IN THE DRAWINGS

REMARKS

DC
RELATED ART
FIG. 3A

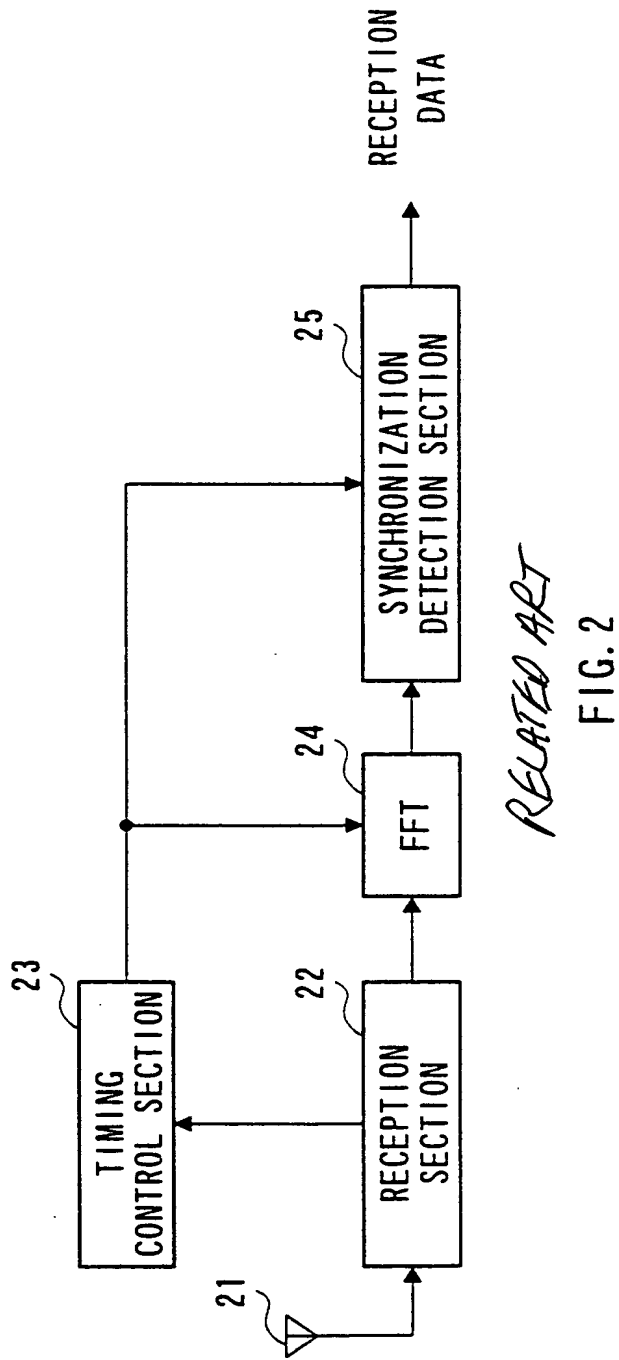
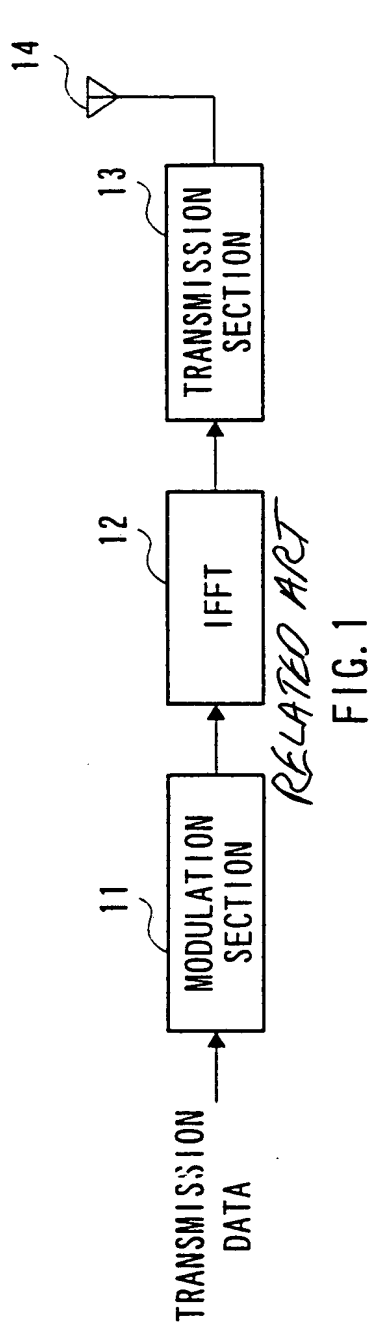
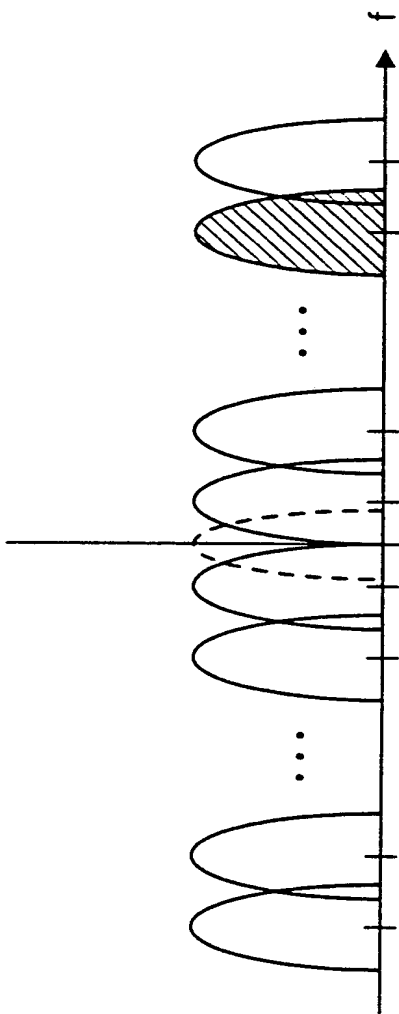
Proposed changes to Figs. 1-3A are submitted herewith, with
a Letter to the Official Draftsman.

Proposed changes to Figs. 1-3A are submitted herewith to overcome the objections thereto. Regarding the issue of a missing Fig. 1 from the application, Fig. 1 is on the same sheet as Fig. 2.
